**REZONING &  
SUBDIVISION STAFF REPORT****Date: August 20, 2015****APPLICANT NAME**

Airport – University Subdivision

254, 256, 260, and 264 Dogwood Drive  
(Southwest corner of Airport Boulevard and Dogwood Drive extending to the Southeast corner of Airport Boulevard and South University Boulevard).

Subdivision to create one legal lot from four legal lots, and  
Rezoning from R-1 to LB-2 to allow a restaurant.

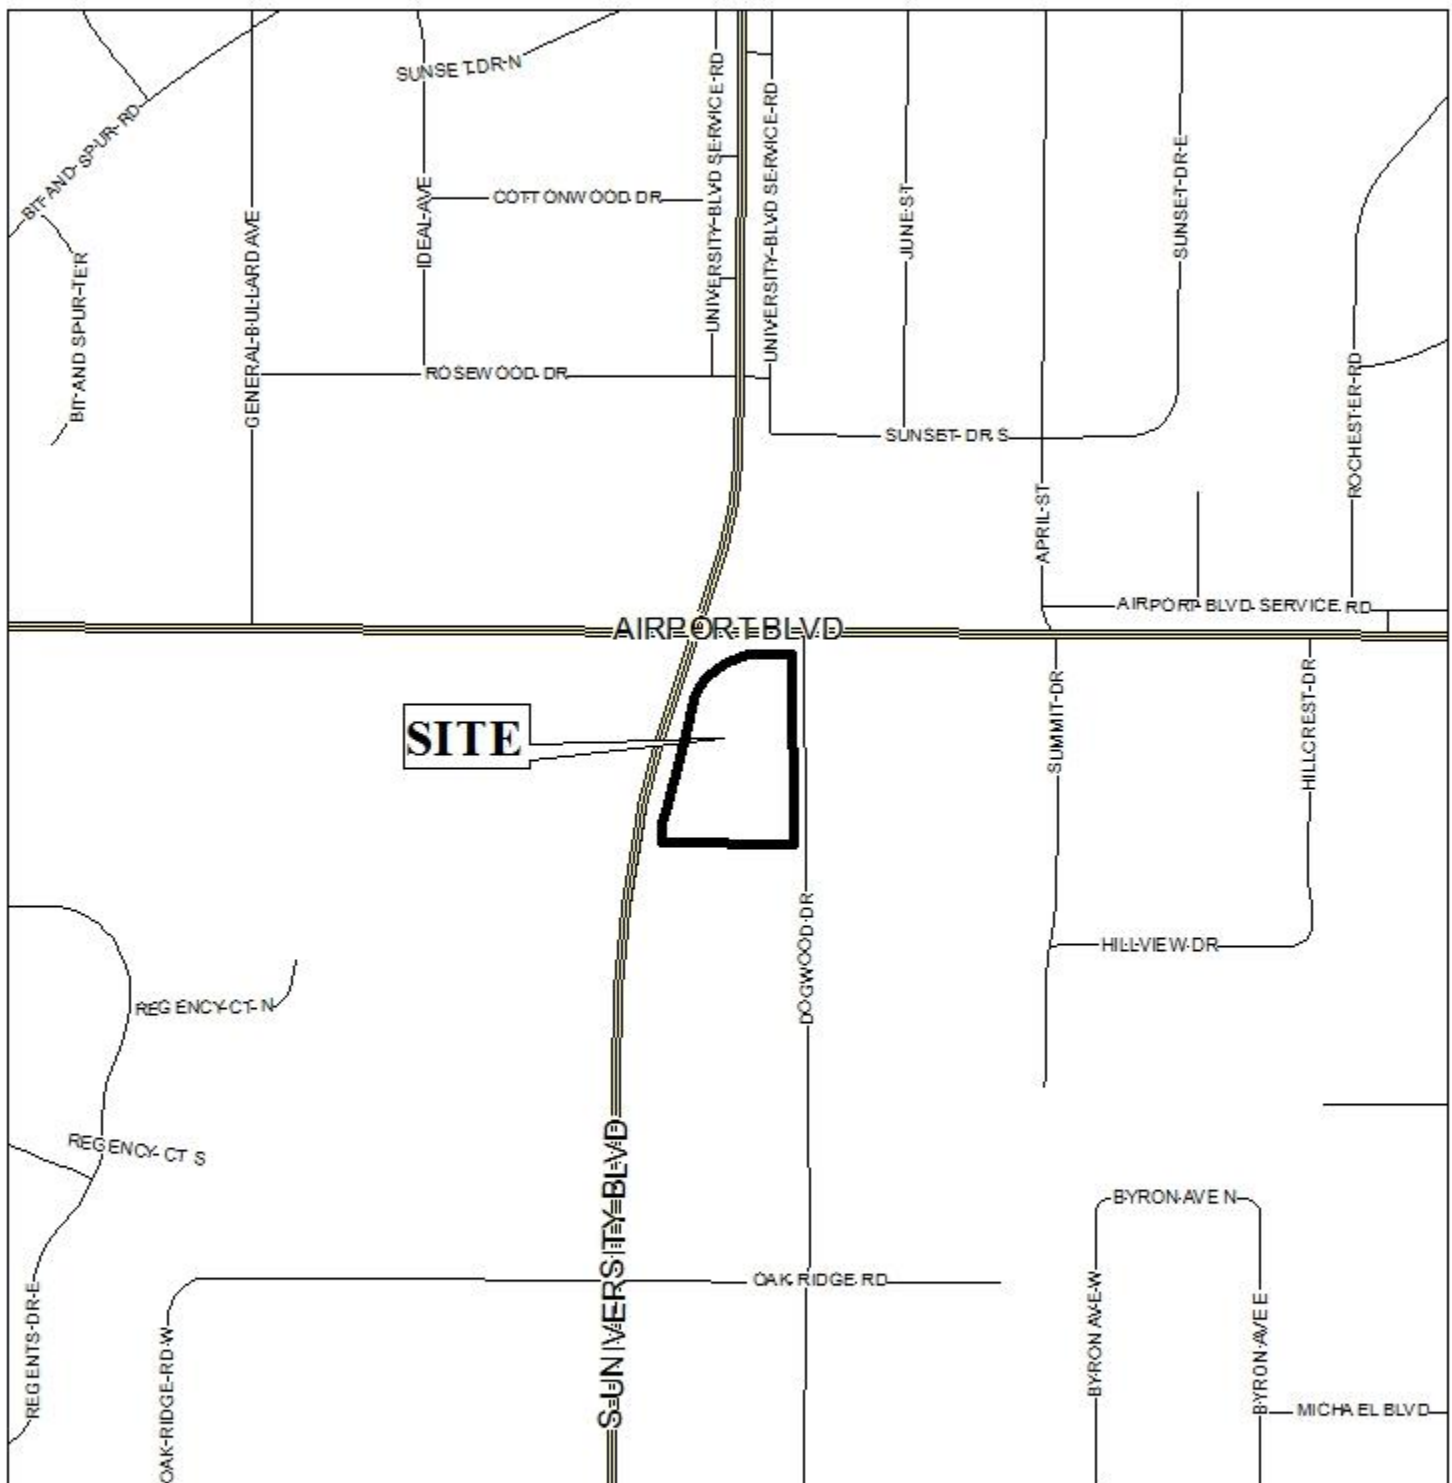
The plan illustrates the proposed full access drive onto University Boulevard. Typically, access to a minor residential street such as Dogwood Drive would not be desirable; however, it seems that the location of the driveway on Dogwood Drive would appear be a safe distance from Airport Boulevard, the driveway location would seem to be the least problematic when compared with a curb-cut to Airport Boulevard, and provide some distance from the residential neighborhood. If approved, the site should be limited to the curb-cut to University Boulevard as shown, as well as the one curb-cut to Dogwood Drive. This would help minimize the impact on the residents of Dogwood Drive and the remainder of the subdivision.

As submitted, the application and site plan indicate that there are no 24" and larger live oaks on the site; however, comments from the Urban Forestry Section and aerial photographs indicate that there are. Further, a site visit was made for previous applications and a 28" Live Oak was found on the site.

Other conditions of approval on a previous application that are not shown on the current site plan, but would still be applicable to the new proposal is a 6' (minimum) privacy fence or wall to accompany the 25' (minimum) landscaped buffer along the South property line, with the exception of the drive from University Boulevard, and provision of screening of parking in compliance with Section VI.A.3.i for the entire Dogwood Drive frontage, with the exception of the setback from Airport Boulevard for the visibility triangle (Section IV.D.4).

The plan also does not illustrate the planting of trees along University Boulevard or Airport Boulevard. While trees do not have to be spaced at 30' intervals, trees for a particular frontage do have to be planted (and maintained) along that frontage. If approved, this would be reviewed during the permitting process.

The site plan submitted does not depict any tree and landscape calculations. Staff is aware that the site has existing trees however there has been no information provided depicting tree and landscaping requirements except for the labeling of a 25' landscape buffer. Based on aeriels it would appear that while some trees will have to be removed, those are predominately in the center of the site and not along the perimeter. Also, a large landscaped buffer, which exceeds Zoning Ordinance requirements, is to be provided along the South property line.

The plan does not indicate the provision of a sidewalk along all street frontages; however, unless a sidewalk waiver is requested and approved, sidewalks will be required.

Other concerns relating to the site plan as proposed are the location of the Drive Thru order stations at the South end of the building and lack of information regarding delivery trucks and circulation. The order stations could generate noise that would affect the neighbors to the South, and if approved as submitted, delivery trucks could be traversing Dogwood Drive, a minor

residential street, regularly. Queuing spaces are also not illustrated on the site plan as required in Section 64-4.F.2 of the Zoning Ordinance.

A dumpster with an enclosure is depicted on the site plan. If approved, a dumpster in compliance with Section 64-4.D.9. of the Zoning Ordinance will be required.
